ILLINOIS EPA RCRA CORRECTIVE ACTION CERTIFICATION

**Subject: Response to Agency Comments Provided in June 16, 2011 Letter
Equilon Enterprises
Roxana, Illinois
1191150002 -- Madison County
ILD080012305
Log Nos. B-43R-CA-1; CA-3; CA-5; CA-6; CA-7; CA-8; CA-10; CA-11;
and PS11-032**

Response to IEPA Comments – June 16, 2011 Letter

Supplemental Information to the Meeting on August 1, 2011
Scope of Work for Additional Soil Investigation
Roxana Public Works Yard

SHELL OIL PRODUCTS US AT THE WRB REFINING LP WOOD RIVER REFINERY ROXANA, ILLINOIS		PROJECT NO. 21562593
URS		
DRN. BY: djd September 2011 DSGN. BY: dp CHKD. BY: dp	WRR Facility Map with West Fence Line, Groundwater Production Wells and Recovery Wells	FIG. NO. 1

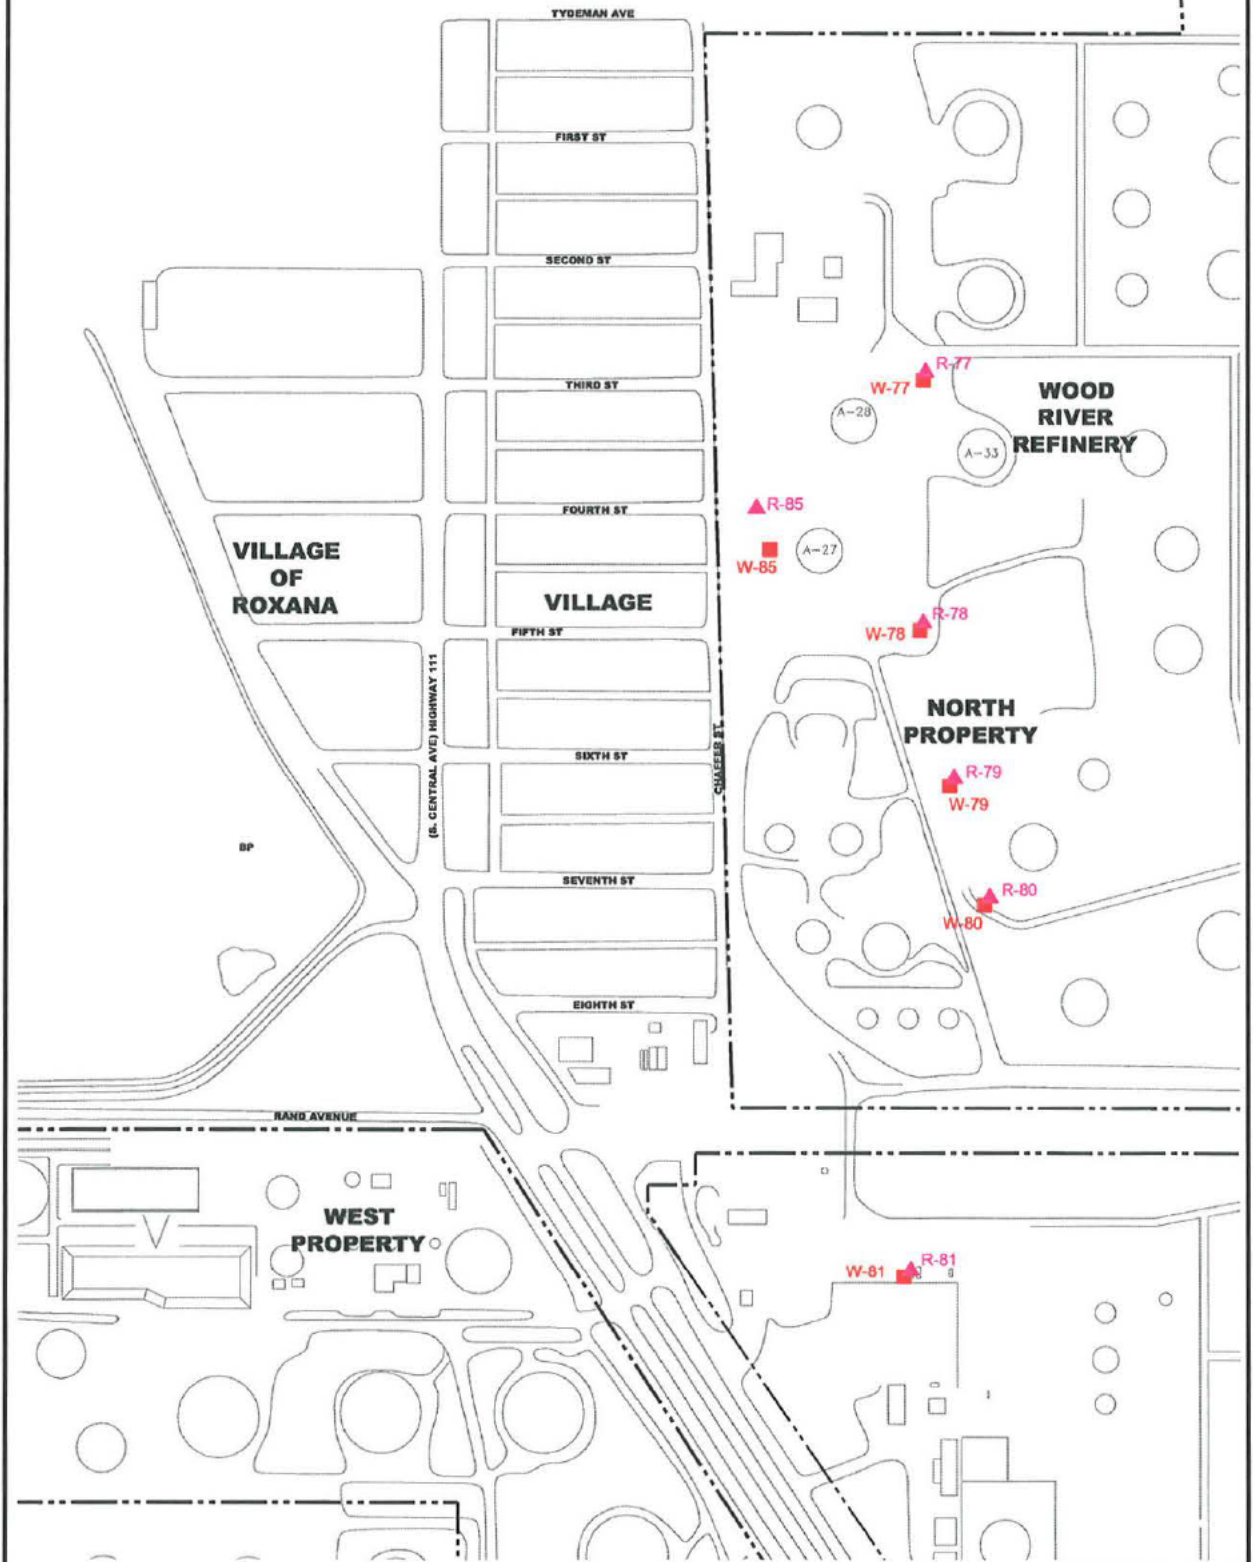
- d. *The facility must also propose a system for removal of groundwater within the upper portion of the main aquifer, where the most significant groundwater contamination exists along the west fence line of the North Property of the WRR and in the vicinity of the Roxana Public Works Yard. Therefore, the facility must combine the skimmer system and groundwater removal from the shallow portion of the uppermost aquifer into a dual phase extraction system. The system must focus on removal of contaminants and enhance the current efforts to maintain an inward hydraulic gradient.*

- i. *Information submitted to date is not adequate to satisfy Condition 15 of the August 5, 2010 Illinois EPA letter (Log Nos. B-43-CA-16 and CA-18). Therefore, the proposal for the dual phase extraction system must be developed in accordance with Condition 15 and the guidance in Attachment C of the August 5, 2010 Illinois EPA letter, "Required Contents of a Conceptual Design Report", to address contamination along the west fence line and the groundwater contamination in the vicinity of the Roxana Public Works Yard.*

- ii. *Existing Water Production Wells at the WRR are screened deep within the aquifer, while the contaminant plume remains much closer to the water table. Therefore, the addition of a shallow pumping system is appropriate.*

The comment is acknowledged. In our August 1, 2011 meeting with the agency, we provided information that a system similar to that contemplated in the comment already exists at the facility. Recovery well Nos. R-71 and R-77 through R-81 are located near the west fenceline of the refinery (**Figure 1**). These wells are screened from a depth of approximately 40 to 80 feet below ground surface (bgs). For perspective, over the past eight months, groundwater levels have been in the range of 406 to 409 feet MSL, or approximately 2 to 7 feet above the tops of the well screens. The pumps in these wells are Grundfos Redi-Flo4™ Model 5E8 stainless steel submersible pumps, powered by 60 Hz motors. These are "total fluid pumps", and consequently pump the liquid (i.e., water or LNAPL) in which they are submerged. These pumps operate continuously, with an individual flow rate of approximately 10 gallons per minute (gpm). In the event LNAPL is not present, the pumps remove groundwater near the top of the aquifer. The LNAPL and/or groundwater that is pumped from these wells is sent directly to tank F-67 for phase separation (if present) and then to treatment at the WWTP. The attached **Figure 2** provides a rough graphical presentation of the well construction for these water production wells and their corresponding oil recovery wells. As shown, the recovery well screens are below the current 2011 average groundwater elevation, as a result minimizing the well/pump's potential for LNAPL removal. However, they are removing groundwater at near the top of the aquifer.
